## RECALL 24V350 REMEDY INSTRUCTIONS

Make(s): AURORA & CATALINA  
Model(s): AART18RD & ACAT18RDL  
Model Year(s): 2024

Concern:  
The furnace may be installed directly to a vinyl floor material, outside of the manufacturers installation instructions.

FIGURE 1

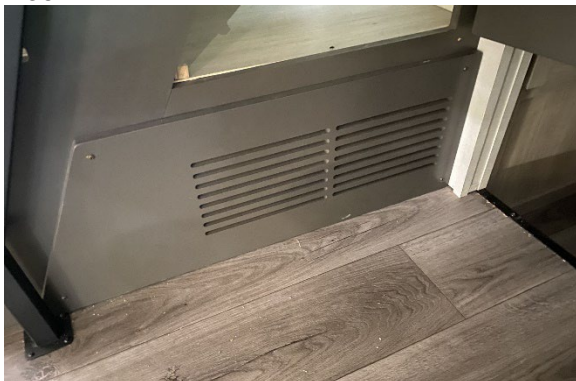
### STEP 1: LOCATE FURNACES AIR RETURN (FIGURE 1);

- REMOVE THE SCREWS AND THE AIR RETURN TO GAIN ACCESS TO THE FURNACE AND SET ASIDE;
- ENSURE TO RETAIN SCREWS AND AIR RETURN TO INSTALL BACK WHEN WORK IS COMPLETE;
